Project :	Restoration of the Blanchette ensemble House, barn and hangar Forillon National Park	Date : 2017.08.16 (AAAA.MM.JJ) File STGM : Q-1679 File JBCA: 2016-193-2 File Tetrattech : 32308TTC File Parcs Canada : 1413-4 Addenda no. : ADD-A01
Owner :	Canada Parks

IMPACT OF THE ADDENDA-A01 ON THE ARCHITECTURE DRAWINGS**BLANCHETTE HOUSE****- Issue of the English version of the drawings (12 pages)**

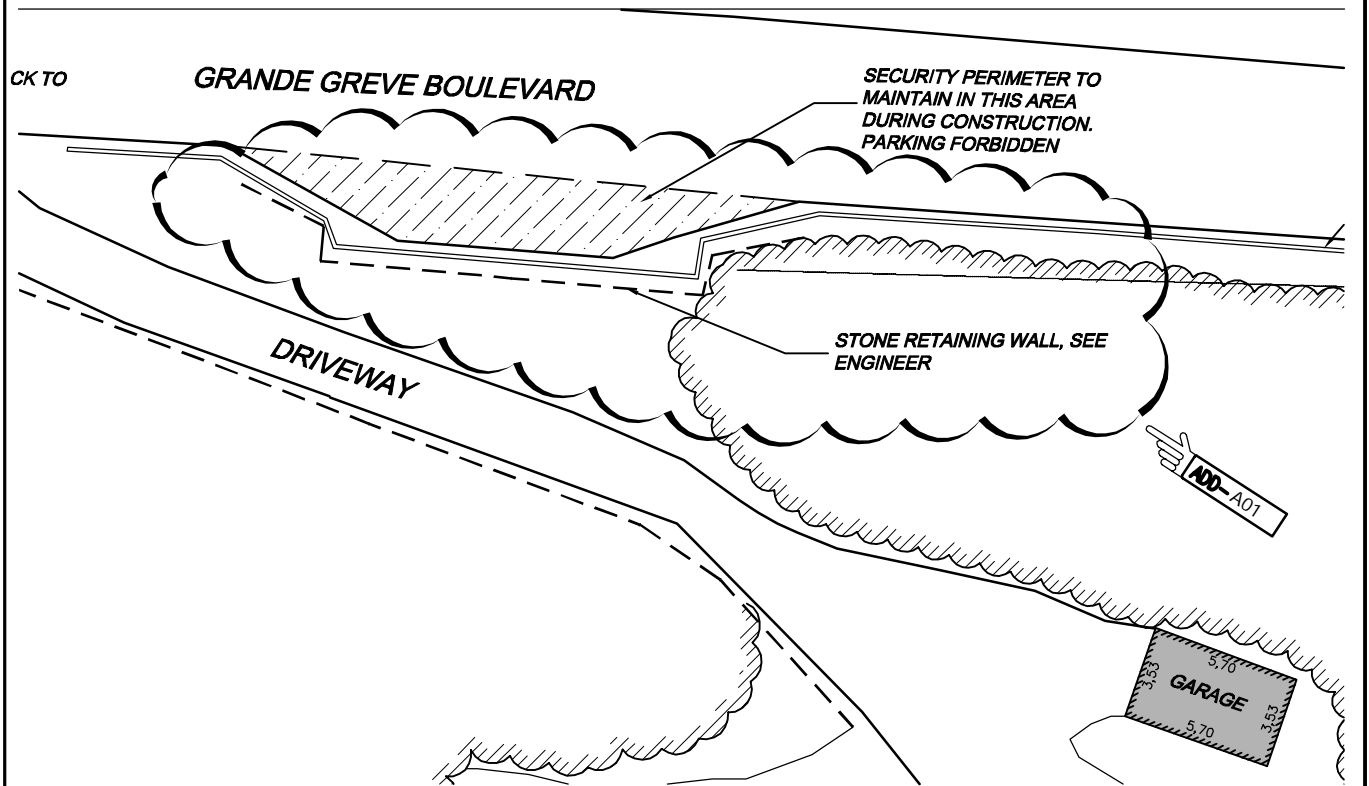
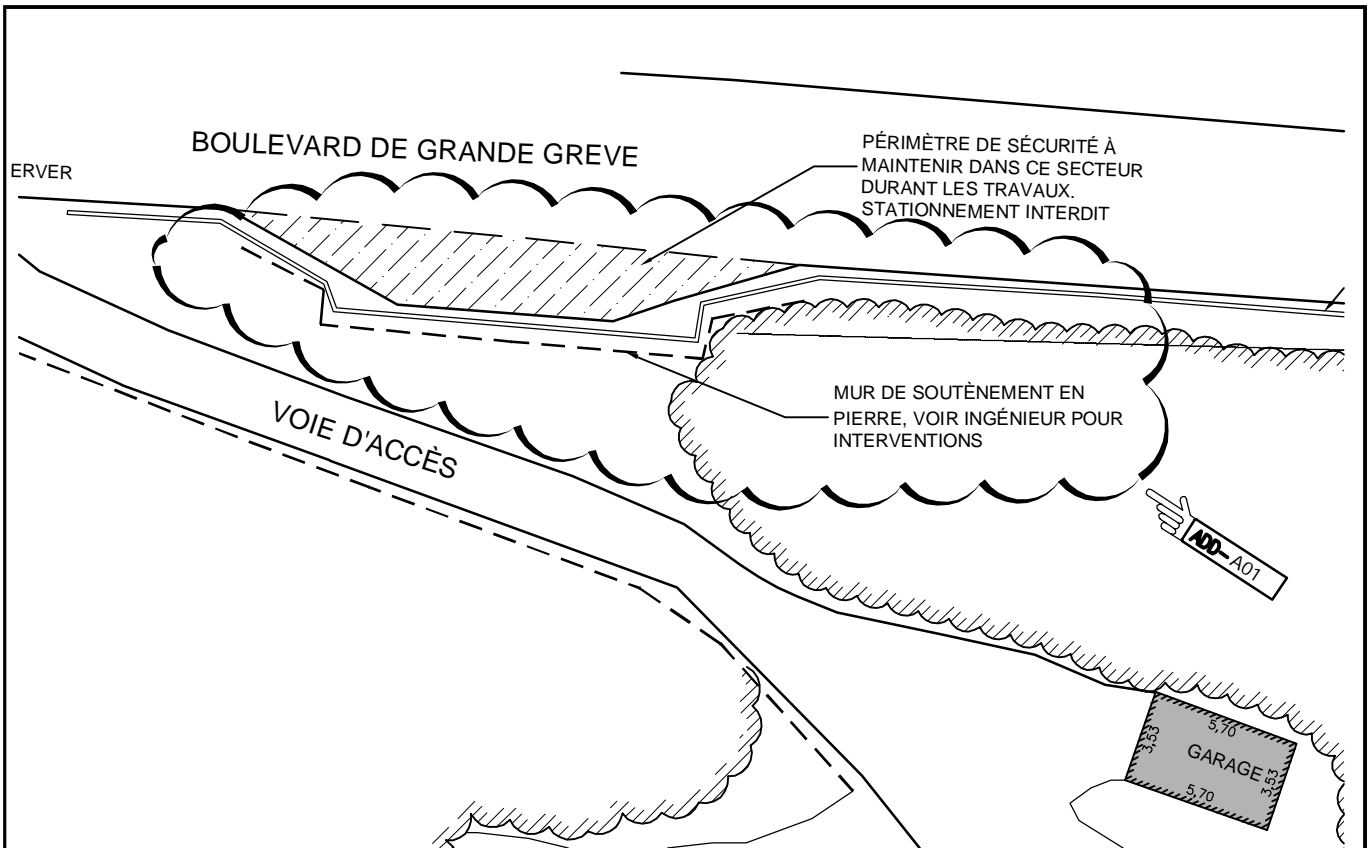
- **Modification of drawing A01**
- New note added on the existing retaining wall related to civil engineer sheetset, see drawing 1 as attachment.

- **Modification of drawing A01**
- New note added on the existing retaining wall related to civil engineer sheetset, see drawing 1 as attachment.

- **Issue of the English version of the drawings (8 pages)**
- **Modification of drawing A01**
- New note added on the existing retaining wall related to civil engineer sheetset, see drawing 1 as attachment.

FRONT ELEVATION

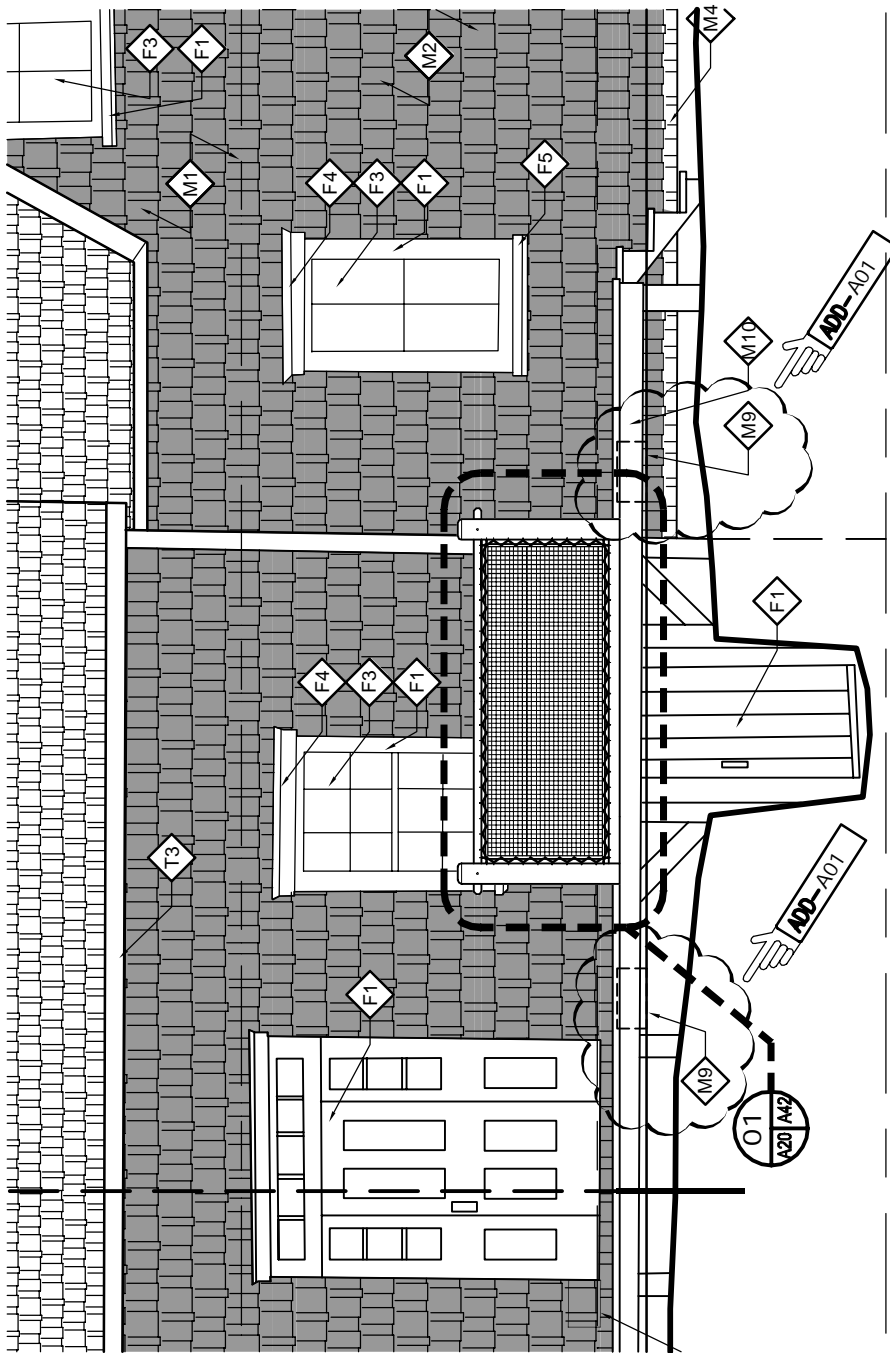
- **Modification of drawings A20 and A21**
- Positioning of the new galvanized steel ventilation grate, see drawings 2 and 3 as attachment.

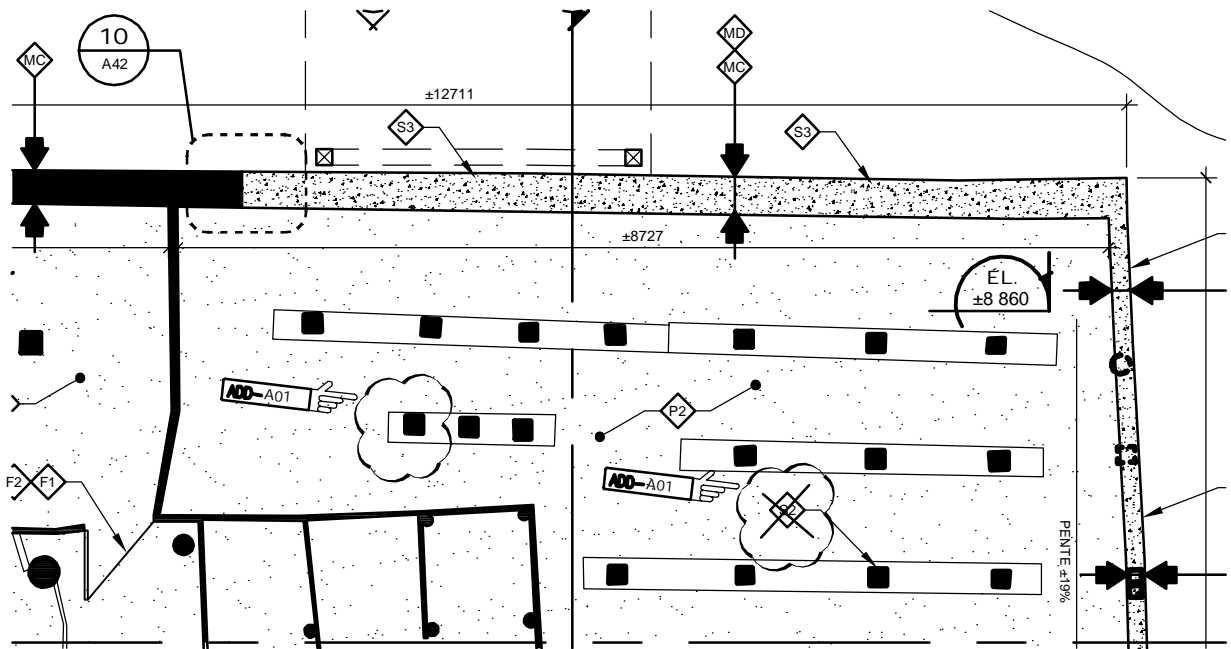
- **Modification of drawing A10**
- Addition of a wooden column: see drawing 4 as attachment
